No.	2023-P285
To	Board of Directors
Date	2023-06-22

Federal Land Use and Design Approval – Parliamentary Precinct – Centre Block Rehabilitation Program – 100% Landscape Schematic Design

**RE: FLUDTA REVIEW – CENTRE BLOCK REHABILITATION PROGRAM (CBRP) 100%
LANDSCAPE SCHEMATIC DESIGN SUBMISSION**

Proposed Landscape Plan (project boundary shown with dashed line). Final number and design of surface parking is excluded from this approval.

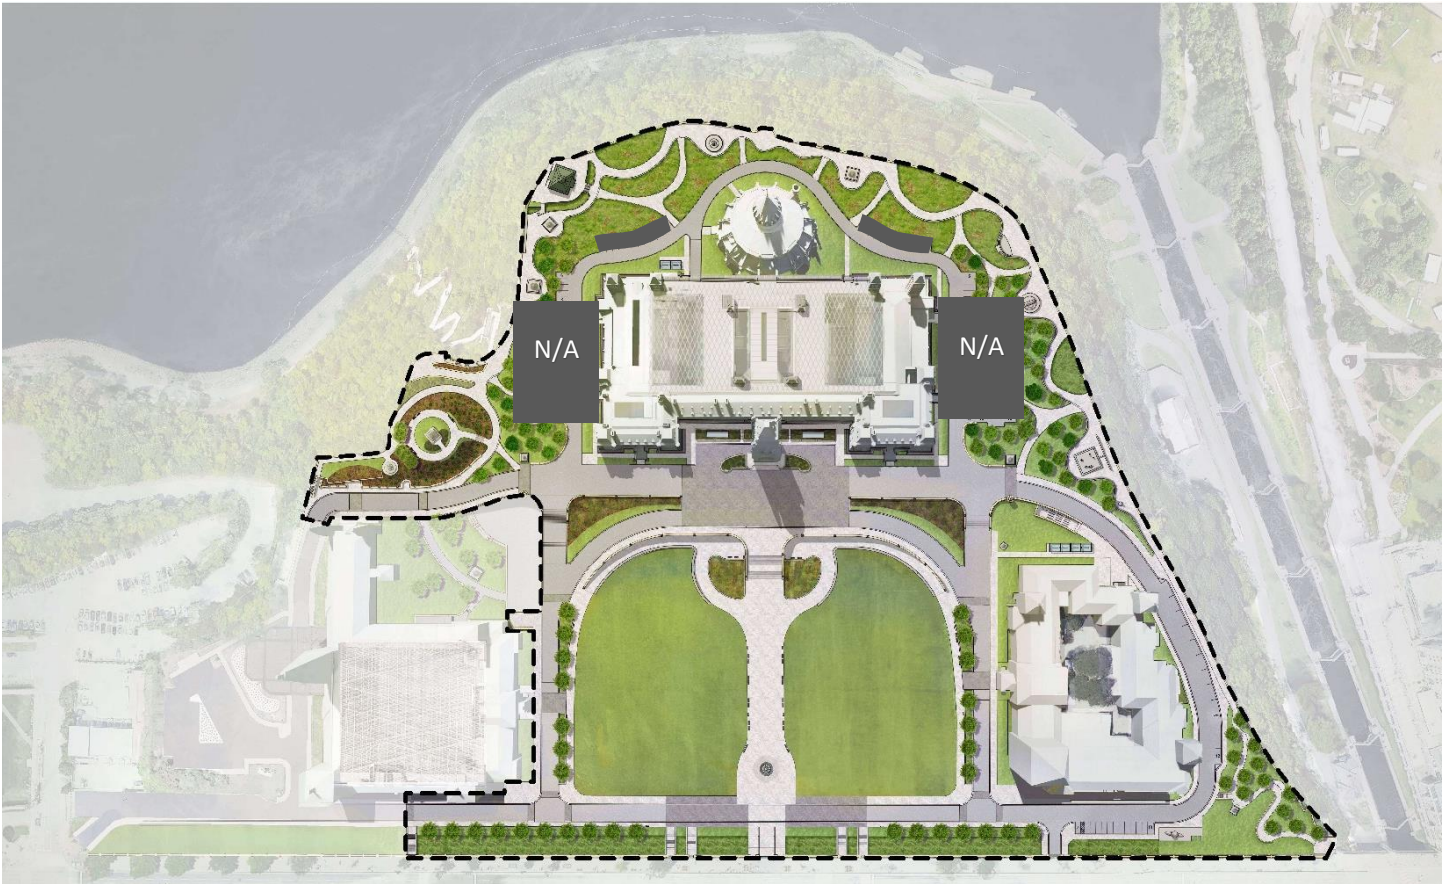
- Further refinement of the planting beds in areas surrounding the Parliamentary Forecourt to fully evaluate the effect of these new elements on the distinct functions of the Formal Lawn and Pleasure Grounds.

- Further details related to the proposed trees south of South Drive (species, canopy characteristics, expected tree heights, etc.) are required to evaluate how key views toward Centre Block will be framed and protected.

- The details, geometry, and proportions of the proposed expanded Centennial Flame Plaza, in combination with the sloped PWC entrance pathways, should be refined in the next phase to mitigate the effect of truncating the central path or dramatically altering its geometry.

- The Ribbon should continue to be developed in the next phase, with specific attention to how this element will complement existing stone walls on Parliament Hill and integrate with the existing perimeter fence. Further refinement is needed to ensure that this design element does not dominate the landscape.

- In the next phase of design, the Proponent team must ensure that bike parking infrastructure is located discreetly, in such a way that it will not be visually dominating or negatively impact views toward Parliament.

- The proposal also included 109 surface parking spaces surrounding the existing Centre Block building which represents an increase from the existing 98 spaces and is in direct contradiction with the policy direction outlined in the Plan for Canada’s Capital, 2017–2067 (2017). This Plan calls for the reduction and gradual removal of surface parking in the Parliamentary and Judicial Precincts. The NCC will pursue further discussions with the Proponent to ensure compliance with the planning framework while meeting the programmatic requirements. The surface parking component will be submitted for approval by the NCC’s Board of Directors at a later date.

- The Proponent is to evolve the layout and design of surface parking in compliance with the Plan for Canada's Capital, 2017–2067 (2017) and in consultation with the NCC, and integrate that component into the subsequent project phase.

Diagram showing proposed new tree locations.

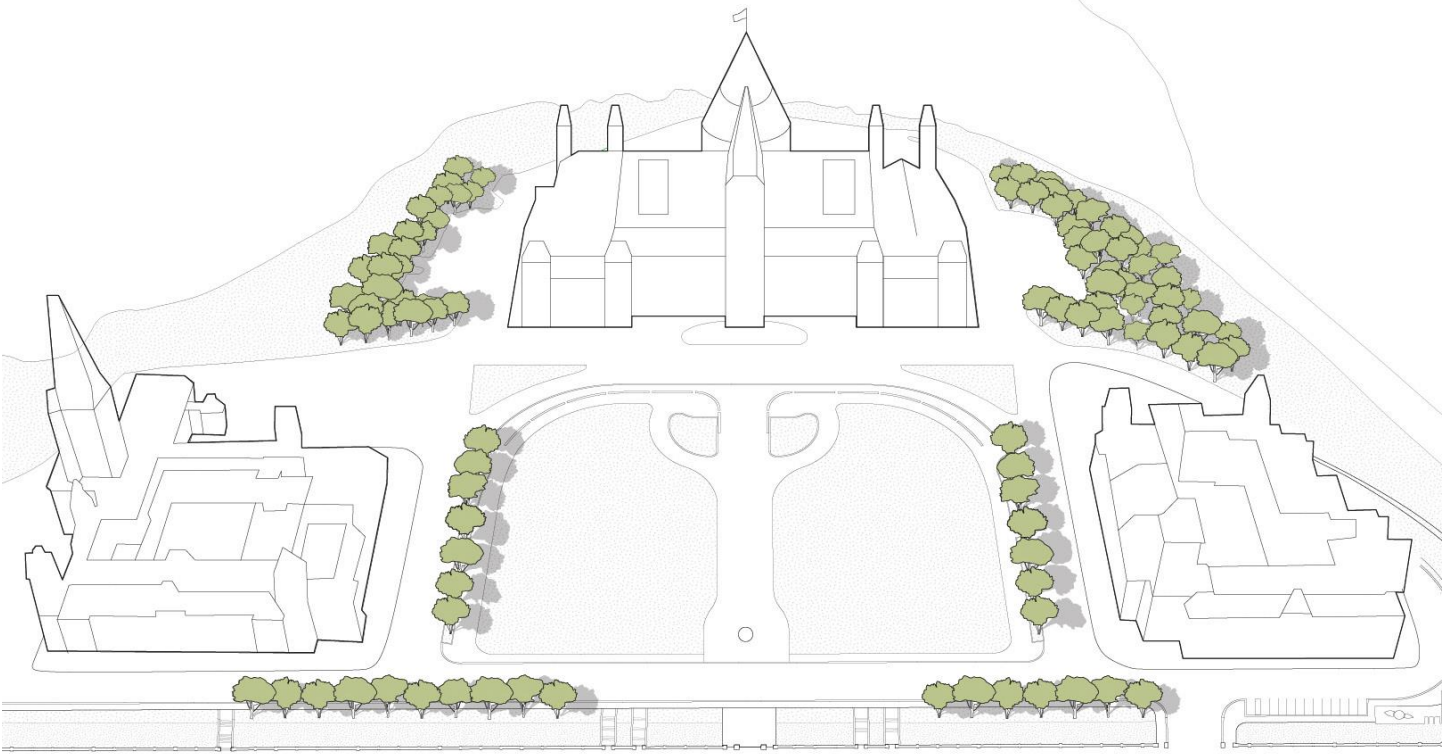
- 3.1. In addition to the preliminary diagram demonstrating the impact of the proposed trees on either side of Queen's Gate on the views toward Parliament from Wellington Street (Figure 5-8 in the submission document), the Proponent Team should demonstrate in more detail how the key views toward Centre Block will be framed and protected. The Proponent should also provide further details related to proposed species, canopy characteristics, expected tree heights, etc. Until then, it remains difficult to evaluate this element of the design.

Revised Emergency East Egress Strategy

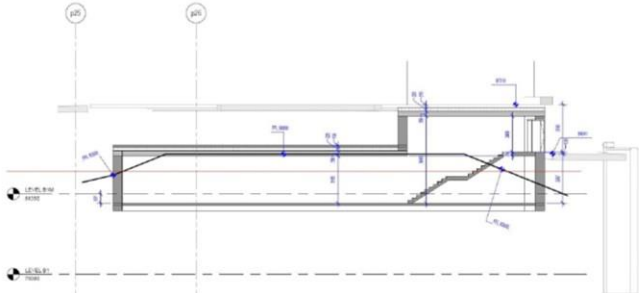
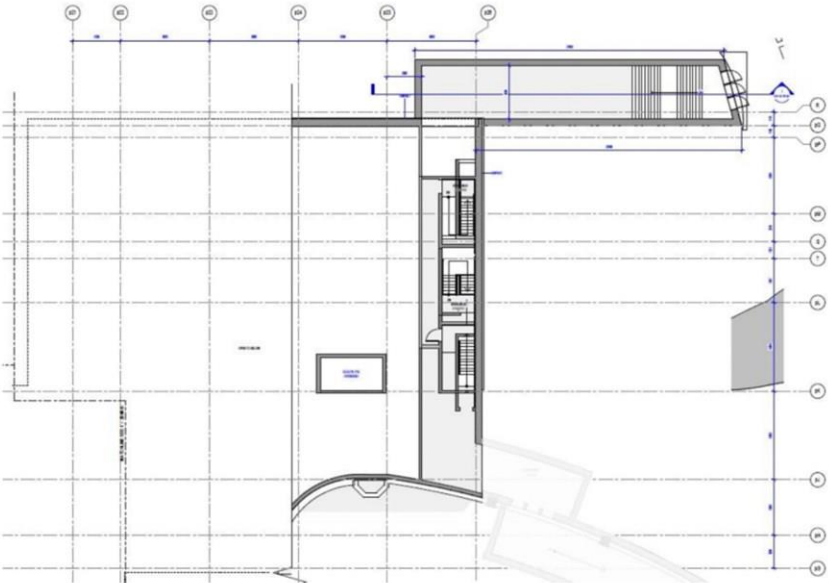
- In response to NCC comments, the proposed east emergency exit from the PWC originally located along the Vaux Wall was relocated to the north of Canal Lane. The integration of this exit with the Ribbon wall should be further studied in design development.

- 2.2. The submission document states that an emergency exit from the PWC is required to the east of the central staircase between Centre Block and East Block. NCC staff does not support the proposed location and current design of this exit. It is understood that a supplemental document detailing the rationale for the emergency east exit is forthcoming; the proponent must demonstrate that alternate design solutions were explored, and demonstrate why, for instance, this exit could not open onto the proposed surface parking location further north on the site. The proposed exit does not meet the *CBRP NCC Performance Criteria #2* related to simplicity of design, which states that:
